Access Compliance Report

Public Rights-of-Way

Intersection ID: 51358	Main Street: PIKE_RD	Cross Street: BRENTMOOR_DR	Location: SE
ADA ID: 9FBF49827F86	Ramp Type: PerpDiag	Initial Pass/Fail: Pass	Overall Compliance: No
Severity Score: 0			
Codes/Mitigation Info/Possible Solution		Field Measurements/Component Compliance

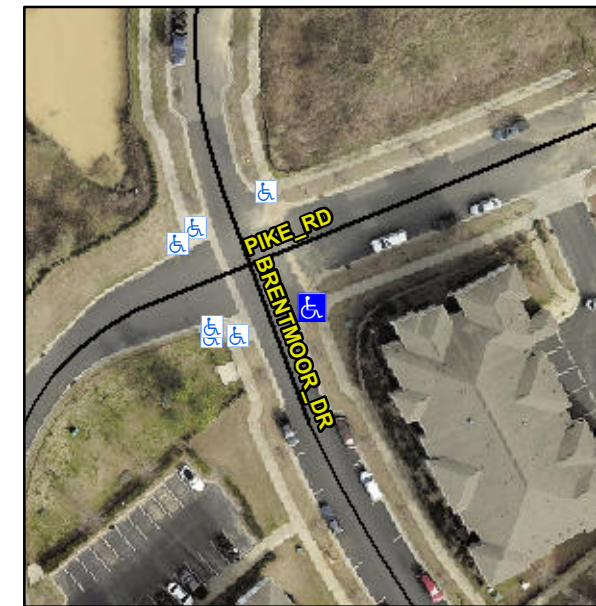
Not Found, R304.5.3

Remove & Replace Curb Slope and Extend Ramp. Remove & Replace Gutter.
